SAFETY RECALL BULLETIN

NHTSA RECALL 18V-815, TRANSPORT CANADA RECALL 2018-663

AUTOCAR, LLC SAFETY RECALL ACX-1803

Autocar has determined that a defect that may present an unreasonable risk to safety exists due to potentially improperly swaged steering assist cylinder hardware on certain model year 2019 Xpeditor vehicles.

Figure 1, Cylinder Bracket Location

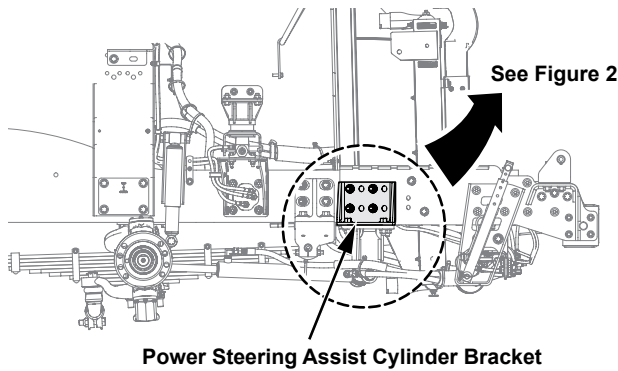
2. Locate the power steering assist cylinder bracket located at the front of the left or right frame rail opposite the steering gear (see Figure 1).

Figure 2, Inspect 4 Huck Fasteners

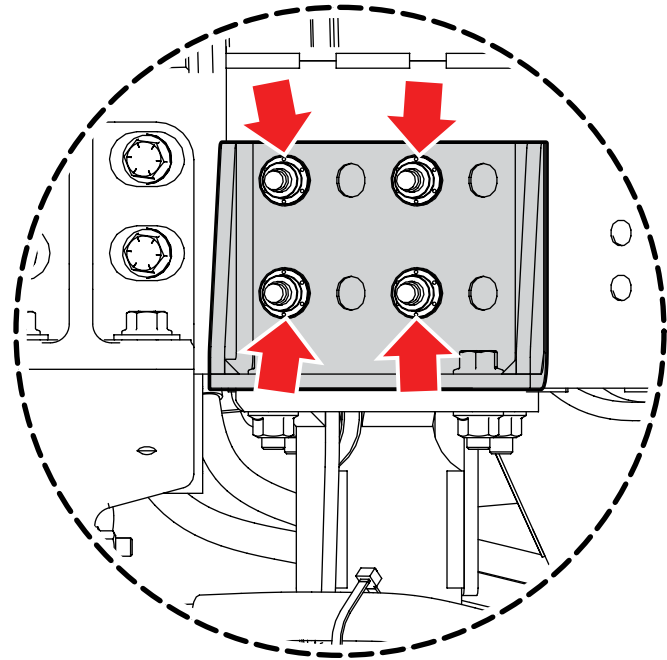
3. Inspect the power steering assist cylinder bracket hardware for looseness, if all hardware is found to be secure, proceed to step 5. If any hardware is found to be loose, proceed to step 4 (see Figure 2).

Figure 3

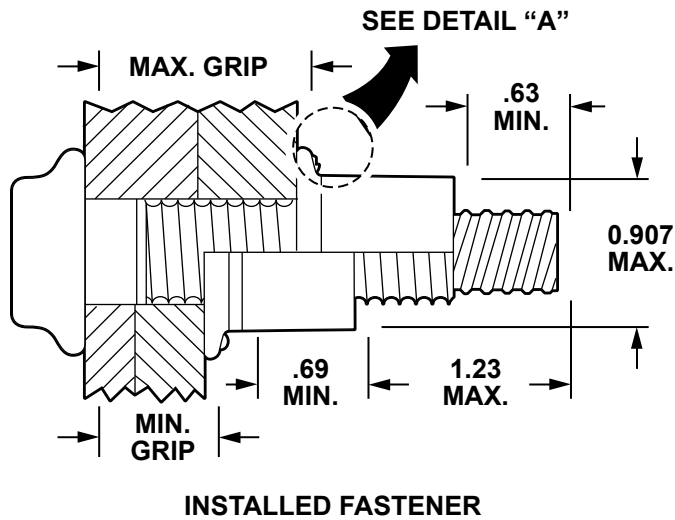
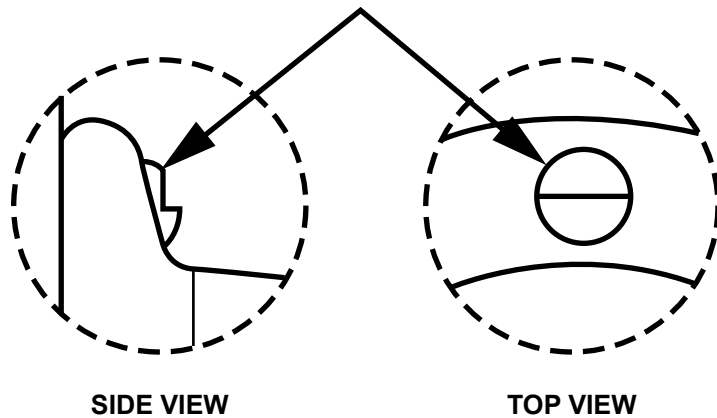
4. Using the appropriate Huck tooling, secure the fasteners as required. If the appropriate tooling is not available, please contact Autocar technical support for direction regarding the repair (see Figure 3).

NOTE: Only .69 Min swage length required to meet minimum values.

**BUMP CREASES ON COLLAR FLANGE
INDICATE FULL SWAGE**
